# GENERAL ELECTRIC

SUBJECT: LOADING CRITERIA FOR SUBMERGED STRUCTURES

#### QUESTION 041.1

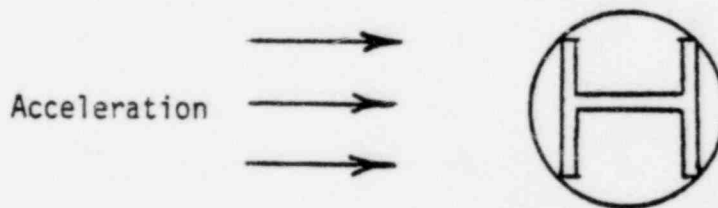
1. Discuss and justify the applicability of this model, which assumes an idealized spherical gas bubble, for air charging through the horizontal vent system following a LOCA. Information should include methods of determining initial bubble pressure, location, size and velocity. Compare and justify these initial conditions with the PSTF test data.
2. Discuss and justify the applicability of this single spherical bubble for the SRV quencher design. Information should include methods of determining initial bubble pressure, location, size and velocity. Method of calculating bubble pressure attenuation should also be provided.

1. Although later stages of observed bubble growth tend toward an elliptical shape, the initial conditions for the assumed idealized spherical gas bubble used in the model are based on observations from PSTF tests which are reported in GE topical reports NEDE-13407, "Mark III Confirmatory Test Programs" and NEDE-13435, "Mark III 1/3 Scale 3-Vent Air Test Series 5806". It was observed that the maximum LOCA bubble pressure load on the suppression pool wall was at the time of initial vent clearing. Submerged structure LOCA bubble pressure loads will also be induced at this time of maximum bubble pressure. The suppression pool boundary LOCA bubble loads identified in Appendix 3B are based on the assumption that the maximum bubble pressure is equal to peak drywell pressure. For submerged structure, LOCA bubble loads are based on a single bubble of the same diameter as the horizontal vent in an infinite pool being charged at the peak drywell pressure. The effects of containment walls, floor, and pool surface are approximated with image bubbles.

2. The procedure for establishing SRV bubble loads on a submerged structure calls for the use of four air bubbles at the quencher. Each bubble is assumed to be spherical in shape, of equal strength, and oscillating in phase with the other bubbles for that quencher. Bubble oscillation is assumed to be isentropic and can be described by the Rayleigh equation. The maximum and minimum bubble pressures are assumed to be equal to the bottom pressures which are determined from the statistical formulations developed and presented in Attachment A of Appendix 3B. The maximum bubble air volume is determined from the initial air conditions in the SRV discharge line and assuming that the bubble temperature is equal to the maximum pool water temperature during SRV blowdown when bubble pressure is maximum.
